Notice of Intent

Sundry ID: 2698966

Type of Action: APD Change

OXY USA INCORPORATED		
BATCH SUNDRY ID: 2698966		
PRECIOUS 30-18 FEDERAL COM	3H	3001546350
PRECIOUS 30-18 FEDERAL COM	32H	3001546611
PRECIOUS 30-18 FEDERAL COM	43H	3001546614
PRECIOUS 30-18 FEDERAL COM	44H	3001546544
PRECIOUS 30-18 FEDERAL COM	171H	3001546581
PRECIOUS 30-18 FEDERAL COM	172H	3001546582
PRECIOUS 30-18 FEDERAL COM	175H	3001546457
PRECIOUS 30-18 FEDERAL COM	176H	3001546462

Figure C] 4 – String – Un Cemented Annulus

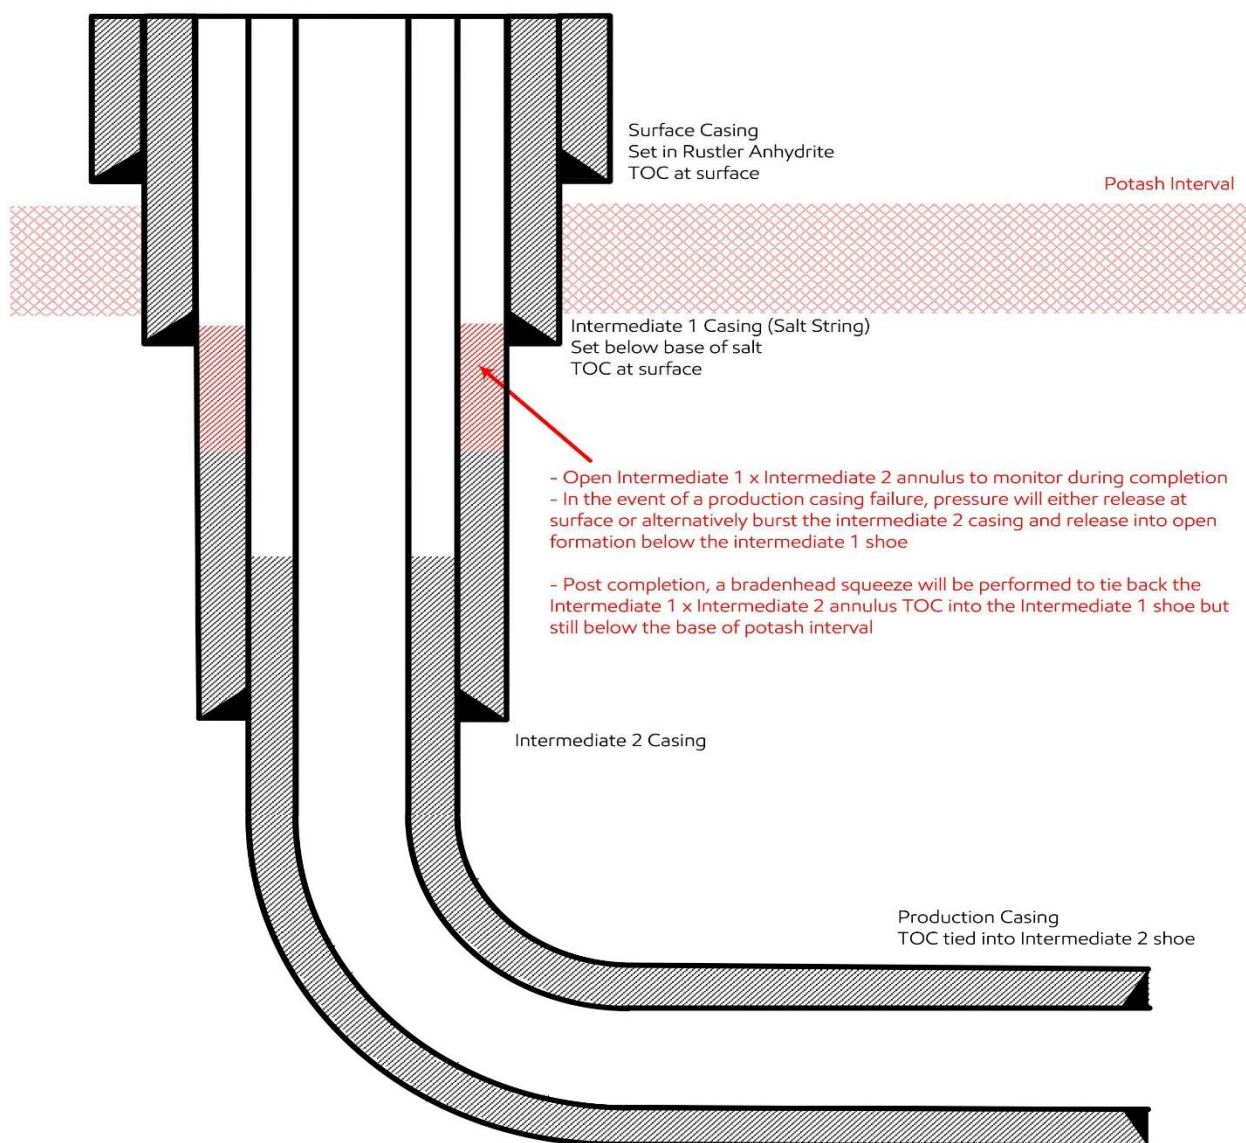
Procedure Description: OXY USA Inc. respectfully requests approved to amend the subject wells AAPD deep intermediate cement job to align with the agreed upon R111-P updates presented at the latest JITC meeting. See the attached updated cementing program and diagram for reference.

Oxy requests to update the Deep Intermediate Cement Job to align with the agreed upon R111-P updates presented from the JITC. (Below table based on Precious 30-18 Fed Com 175H)

**ALL PREVIOUS COAs STILL APPLY. CEMENT DESIGN UPDATE AS PER
KPLA BEST PRACTICES (4-STRING INT1 X INT2 OPEN ANNULUS)**

- Cement to surface. **AS PER MODIFIED DESIGN, THIS CAN BE ACCOMPLISHED POST-FRAC. Wait on cement (WOC) time for a primary cement job is to include the lead cement slurry due to cave/karst or potash.**

Operator has proposed to pump down 7-5/8" X 9-5/8" annulus POST-FRAC. Operator must top out cement after the bradenhead squeeze and verify cement to surface. Operator can also check TOC with Echo-meter. CBL must be run from TD of the 7-5/8" casing to surface if confidence is lacking on the quality of the bradenhead squeeze cement job. Submit results to BLM.
